DOCUMENT CHANGE REQUEST

DCR number 137	Changes required for: N/A	Originator: S Thacker
Date: 2004/08/06	Date sent: 2004/08/06	Organisation: ESA/ESTEC
Status: IMPLEMENTED

Title:	CMOS Quad Bilateral Switch, based on type 4066B		
Number:	9408/005	Issue:	1

Propagation delay times shall be measured as follows:

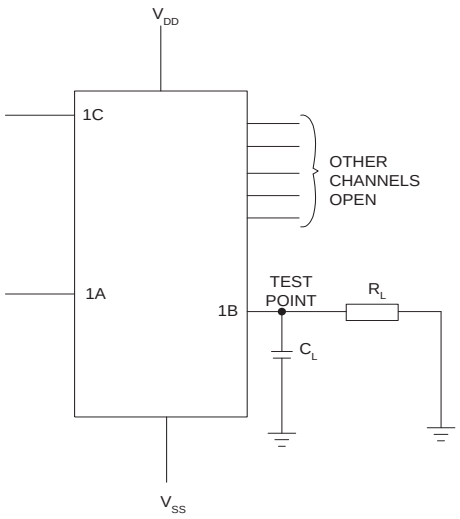
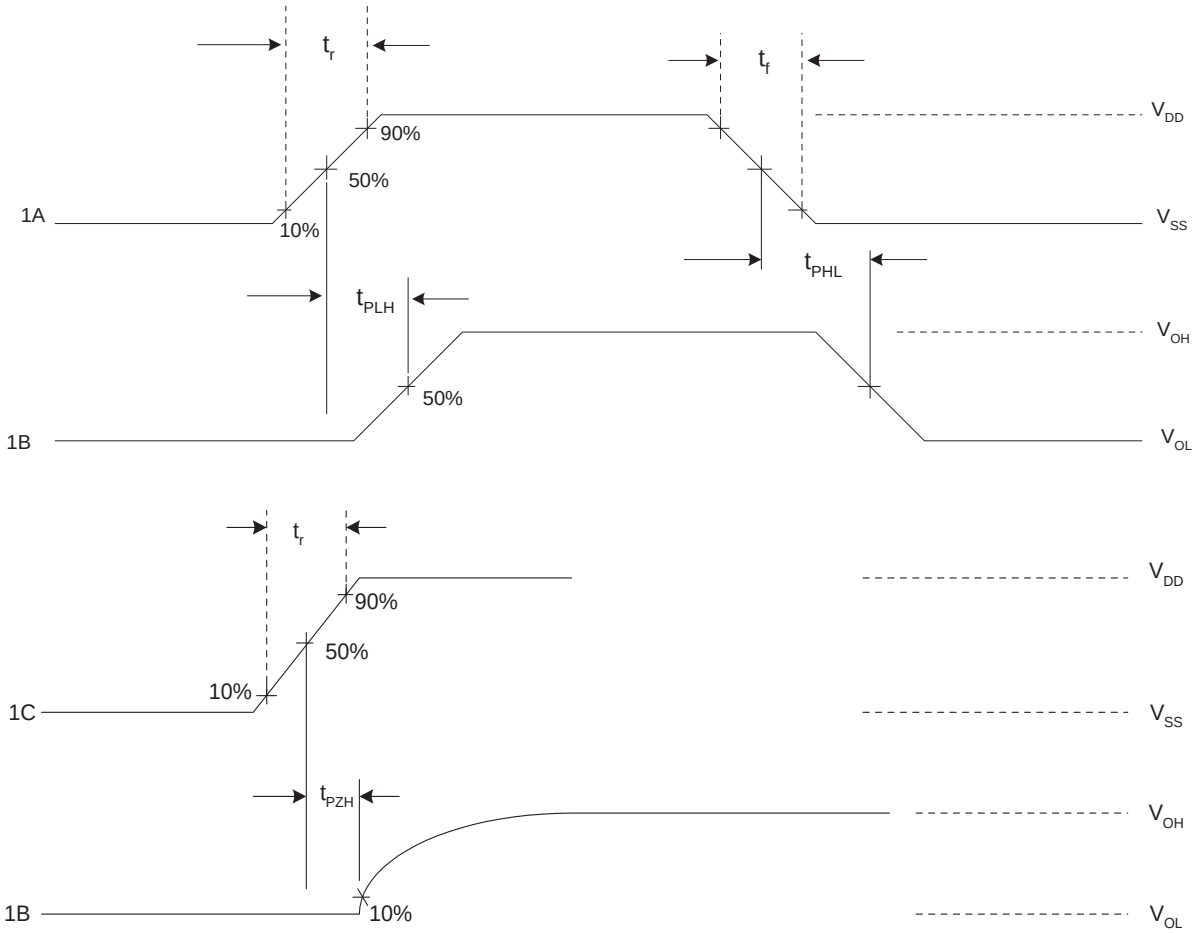
Electrical Test table & circuit (Table 2/Fig 4(p &q) (para 2.3.1/2.3.3 note 8)) - parameters: Propagation times.
Test conditions for channel inputs for tPLH1 (=tPLH), tPHL, tPLH2 (=tPZH) have been amended/clarifed for correct switching including definition of load resistance and capacitance RL & CL.
The switching waveforms have been corrected for tPLH2 (=tPZH) in Fig 4(q)(para 2.3.3 note 8).
- see attached sheets for current and new table & fig/note.

7. Guaranteed but not tested.
8. Read and record measurements shall be performed on a sample of 32 components with 0 failures permitted.
The pulse generator shall have the following characteristics:

V_{GEN} = 0 to V_{DD}; f = 500kHz; tr and t_f ≤15 ns (10% to 90%); duty cycle = 50%. Output load capacitance C_L = 50pF ±5% including scope probe, wiring and stray capacitance without component in the test fixture. Channel bias resistance R_L = as specified.
